Access Compliance Report

Public Rights-of-Way

(Curb Ramps)

Intersection ID: 14734	Main Street: DILWORTH_RD_WEST	Cross Street: ISLEWORTH_AV	Location: E
ADA ID: A8CF13D66549	Ramp Type: BlendTrans1	Initial Pass/Fail: Fail	Overall Compliance: No
Severity Score: 1.25			
Codes/Mitigation Info/Possible Solution		Field Measurements/Component Compliance

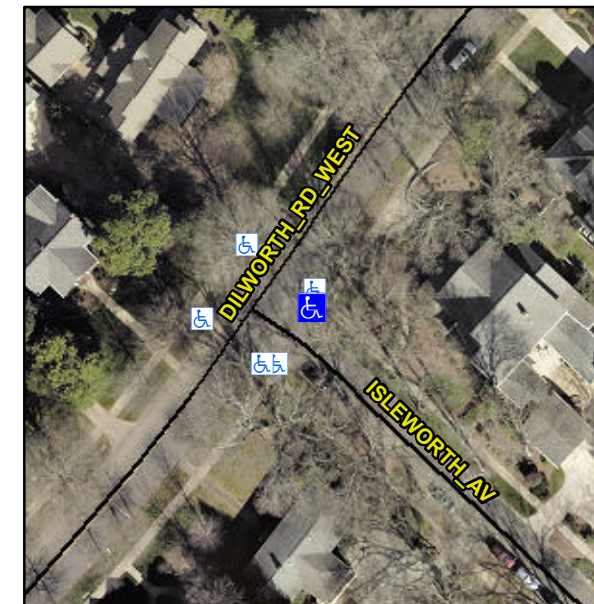
ASP LIP 1.0

PROW/ADA:

Not Found, R304.5.3

Remove & Replace Curb Ramp With Two New Directional Ramps or Equivalent.
